Responses to RC2:

This paper must eventually be published so that prospective ACDL data users can understand how the fundamental calibration coefficients are derived and fully appreciate the uncertainties involved. However, the current manuscript is, regrettably, deficient in several areas. The following topics must be addressed in any revision.

Altitude-latitude cross sections of CALIOP scattering ratio at selected periods since the beginning of the mission (Vernier et al., 2009).

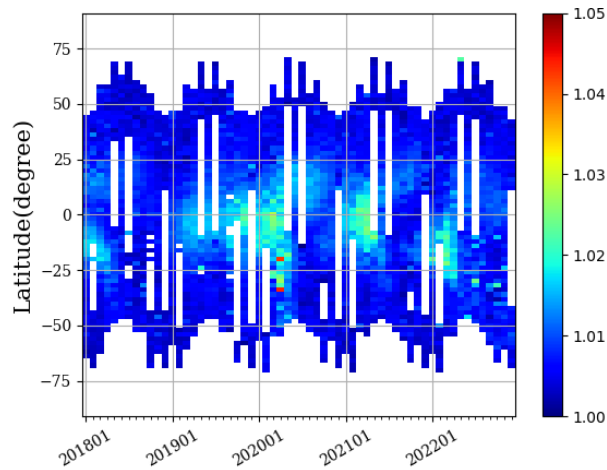
24. Line 125: How can “the signal quality evaluation and atmospheric aerosol distribution” be done before the signals are calibrated? Or is external information used to assess aerosol loading? Please explain.

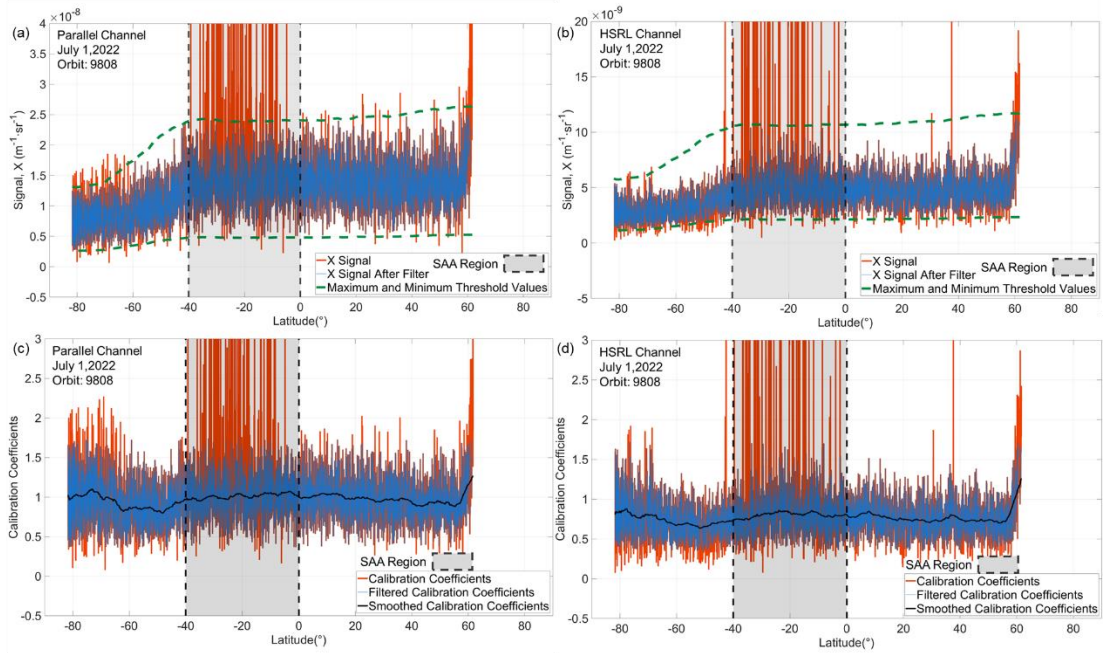
75. Figure 7: Please explain why the minimum threshold is chosen to be so much tighter than the maximum threshold

76. Figure 7: according to the annotations in the top left corner, panel (c) does not show parallel channel results, but is instead a duplicate of panel (d).

AR: The selection of the scaling factor is based on the statistical analysis of the signal intensity distribution of the high-energy signals, Since the ACDL signal basically follows the **Poisson distribution** (as shown in the figure below), with drastic changes in the low value region and smoothness in the high value region, different factors are selected in the high and low value regions to ensure the accuracy of the data. Therefore, in this study, the scaling factors were chosen to be asymmetrical -0.5 and 1.5.

AR: We feel sorry for our carelessness. In our resubmitted manuscript, the figure is revised.

Figure 8: The percentage of rejected profiles for ACDL nighttime calibration (July). (a) Parallel-polarized channel, and (b) HSRL channel

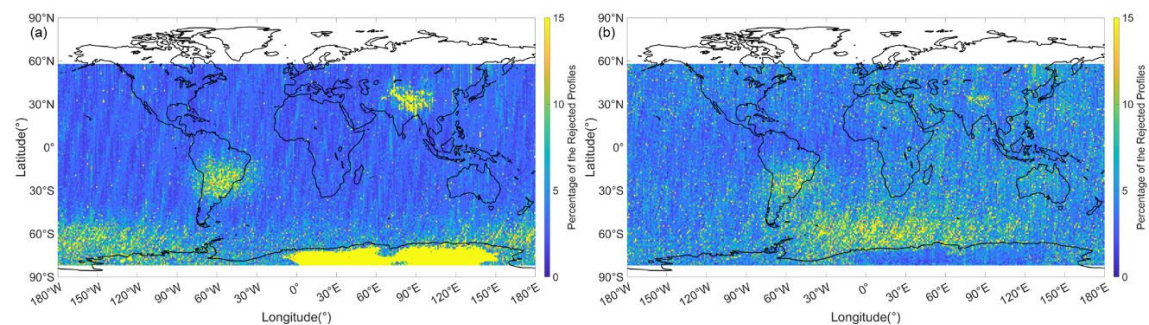
82. Line 373: A map showing frequency of rejected samples (e.g., similar to figure 16 in Hunt et al., 2009) would make a nice addition to this manuscript.

AR: Thanks for your advice. We have added the figure 8 for subscript the percentage of the rejected profiles.

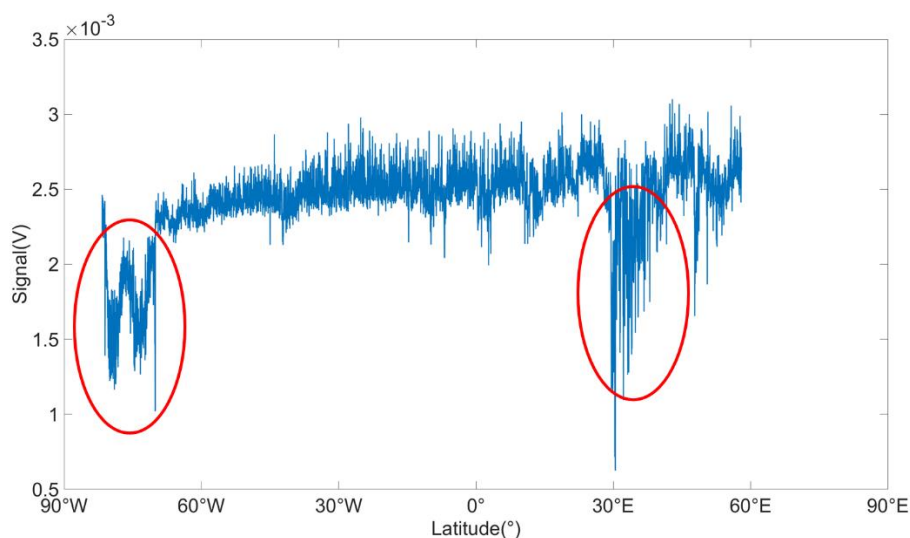
96. Discussion and outlook: This section needs extensive revisions. The explanations offered by the authors for various artifacts in the spatial distribution of calibration coefficients are not plausible.

AR: Thanks for your kind reminder. We have revised the section below:

Figure 13: Result of global calibration coefficient on a 1° latitude × 1° longitude grid for July, 2022. (a) The results of parallel channel and (b) the results of high-spectral-resolution channel. The red circles indicate the SAA region.

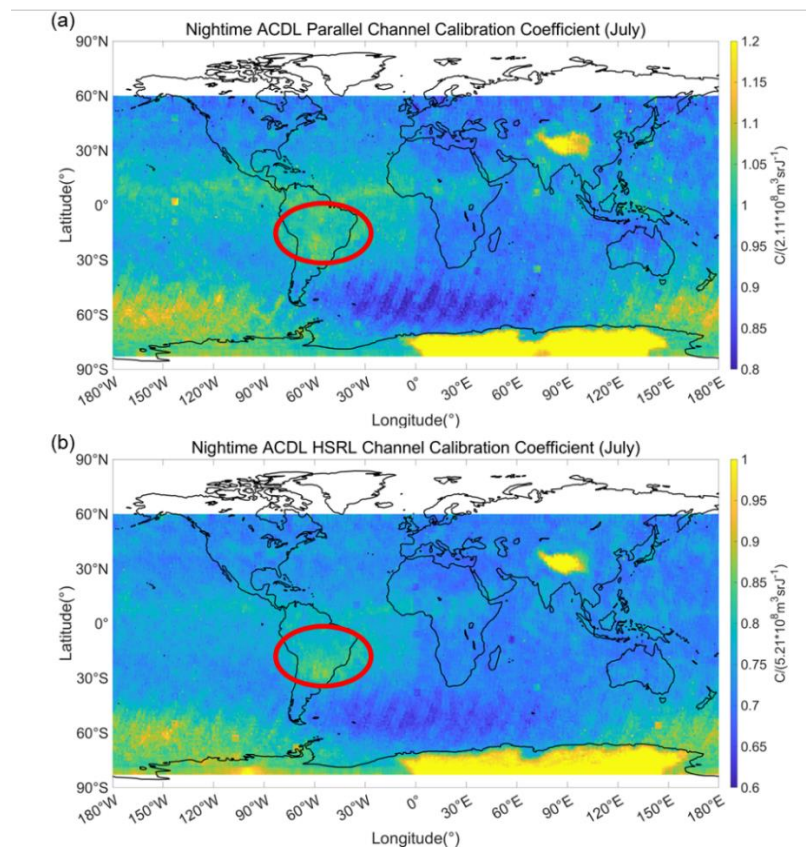
103.Figure 13: (1) What causes the abrupt calibration discontinuity seen in the red ovals?

- (2) Why are the calibration coefficients in the yellow ovals so much lower than elsewhere?
- (3) Drawing the SAA boundaries on these plots would help readers identify regions that are especially prone to high noise excursions that might influence the magnitude of the calibration coefficients

- (1) As a schematic representation of the statistical results, the global results of the calibration coefficients have a number of problems that we have not noticed. The abrupt calibration discontinuity, as shown by the red ovals in the figure, is partly due to the visual illusion caused by the color bar. The other reason is due to errors in the global distribution and dispersion of the aerosols, and also the insufficient amount of data in this region.
- (2) The lower molecular number densities at high latitudes in the Southern Hemisphere winter result in

a weaker signal measured by the ACDL, and thus lower calibration coefficients to increase the signal strength. We assume that the regions of high values of ellipsoid-like calibration coefficients on both sides of the same latitude are caused by auroras, and that the background removal algorithms are not effective in reducing the effects of auroras.

(3) Thanks for your advice, we added the circle that illustrates the SAA region to the figure 13.
